LIGA PUERTORRIQUEÑA
CONTRA EL CÁNCER

HOSPITAL ONCOLOGICO
I. GONZALEZ MARTINEZ
CENTRO MEDICO
RIO PIEDRAS, PUERTO RICO 00935
TELEFONO 763-4149
APARTADO 1811
HATO REY, PUERTO RICO 00919

RE: 19140; 030-14696
ATT: Mrs. Carol Connell

This is in response to your letter dated November 14, 1985 related with the application of amendment to our license No. 52-13471-02.

Reduced Floor Plan to Show Restricted Areas

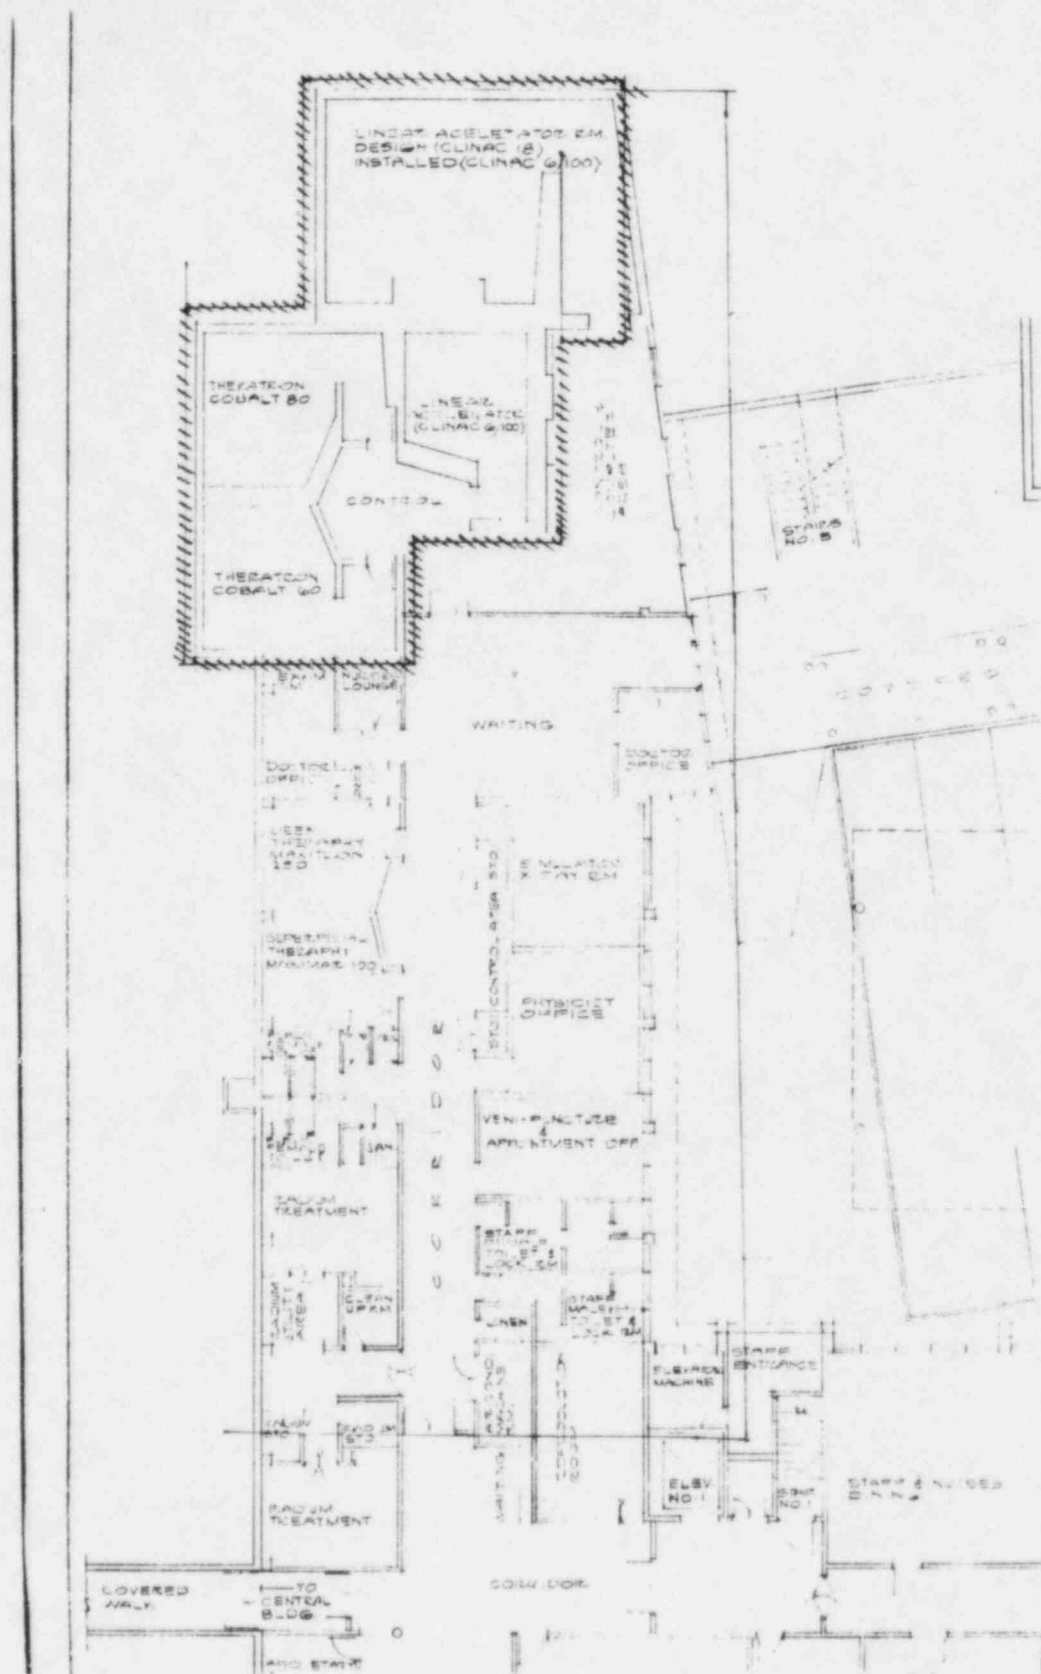
Concerning paragraph No. 1 of your letter, the areas outside the south wall marked as nurse lounge and examining rooms are exclusively utilized by the Radiotherapy Department. All personnel working in this area are monitored with monthly film badge, (see complete Radiotherapy Department floor plan attached).

In relation with the amount of shielding for the south wall we have concluded that as per N.C.R.P. Report No. 49 "Structural Shielding Design and Evaluation for Medical Use of X-Rays and Gamma Rays of Energies up to 10 MeV", appendix B; page 60 and 61; formula (6g); table B-2, figure 15, the calculations revealed that 10.7 inches of concrete is needed. Remember that this is an existing structure and not a new facility.

Considering paragraph No. 3 we are asking for an specific exception to build a fence outside the perimeter of the ceiling slab. The fence consist of a 5 feet high cyclone fence wire mesh around the ceiling slab. The entrance gate of the fence is locked and keys are kept in the security area. The

security services are instructed to alert the Radiotherapy Department staff when the gate is opened for any reason. The four sides of the fence are posted with a large radiation area sign to alert people of the possible hazard.

Previous to start utilizing the unit for treatment a full survey is going to be performed to verify the integrity of the shielding.

If for any reason the exposure rate is more than 100 mrems/week at any of the adjacent rooms the utilization of the unit will be postponed until the maximum permissible doses are obtained.
